**MONTGOMERY COUNTY PLANNING DEPARTMENT**  
THE MARYLAND-NATIONAL CAPITAL PARK AND PLANNING COMMISSION

MCPB  
Item No.  
1-3-08

**MEMORANDUM**

SUBJECT: DPWT Docket No. AB-694 Portion of Bent Arrow Drive, Clarksburg  
DPWT Docket No. AB-695 Portion of British Manor Drive, Clarksburg  
DPWT Docket No. AB-696 Portion of Granite Rock Road, Clarksburg  
DPWT Docket No. AB-697 Portion of Robin Song Drive, Clarksburg

# ATTACHMENT B

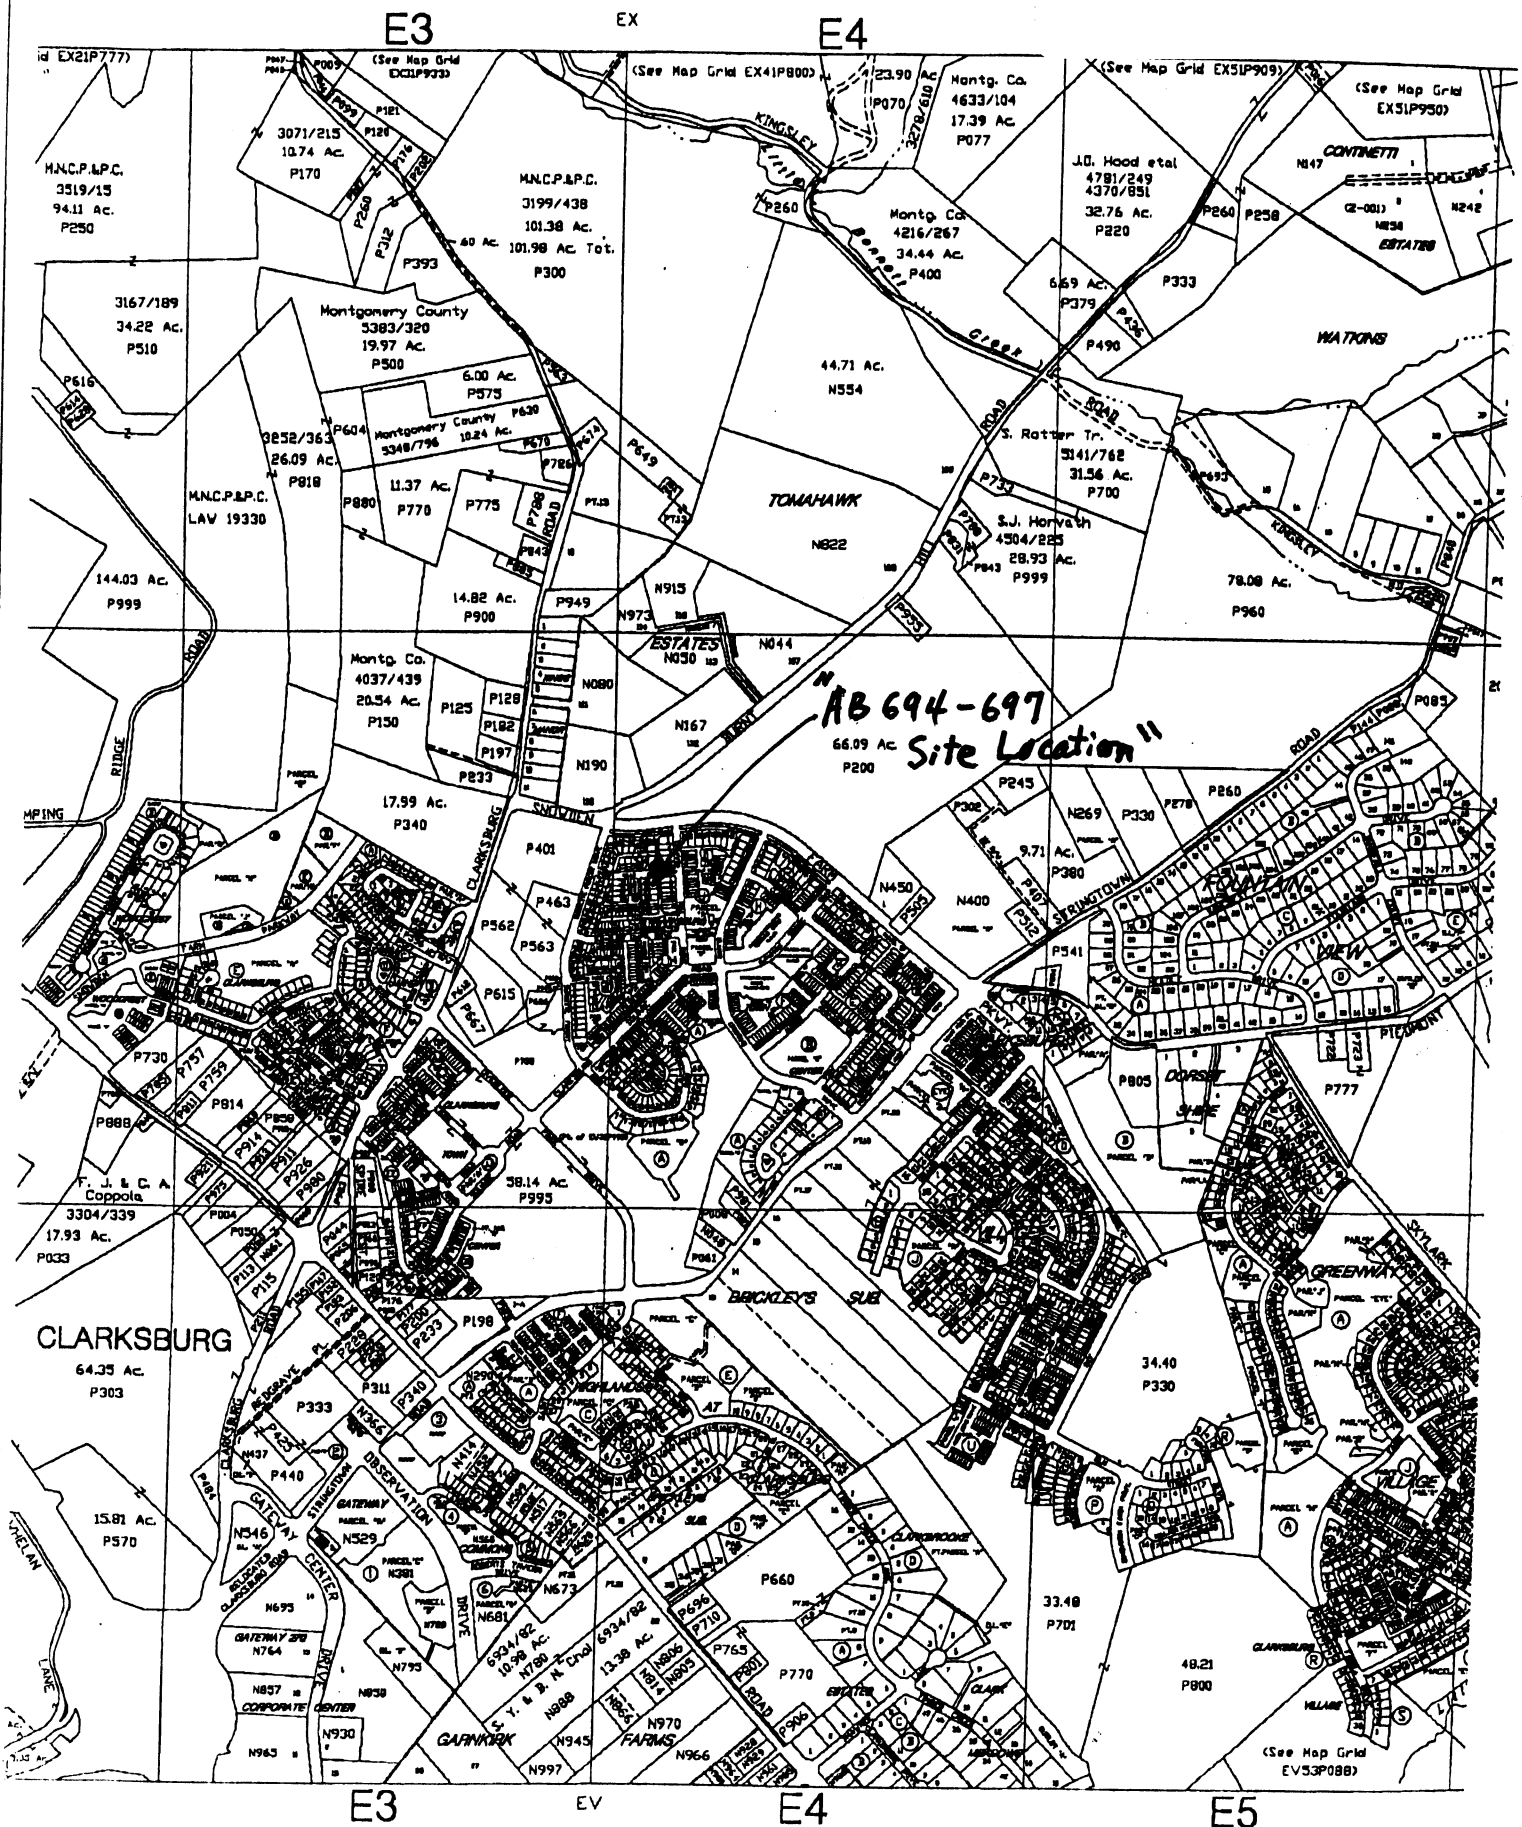
These abandonments are for portions of the dedicated right-of-way of four streets in Clarksburg Village as shown on the general location map (Attachment A) and the detailed drawing (Attachment B).

The purpose of these abandonment requests is to modify the right-of-way from 50 feet (Department of Public Works and Transportation Design Standard mc-210.02) to 27feet 4 inches (mc-210.03) by eliminating 11 feet 4 inches of right-of-way on each side of the subject four streets. According to the Clarksburg Village Compliance Program, approved by the Planning Board on October 5, 2006, changes to the right-of-way will then be used to determine setback distance of eight constructed homes, enabling these homes to conform to County Code. Thus, these abandonments are consistent with the Montgomery County Planning Board approved Compliance Program and

**Staff recommends approval of the subject abandonments with the following condition.**

- 1. The applicant retains all right-of-way being abandoned in a public improvement easement.**

Staff concludes that the portion of the right-of-way of the four streets being abandoned is not necessary for present or anticipated public use except retaining all right-of-way being abandoned in a public improvement easement to be identified on the record plat.
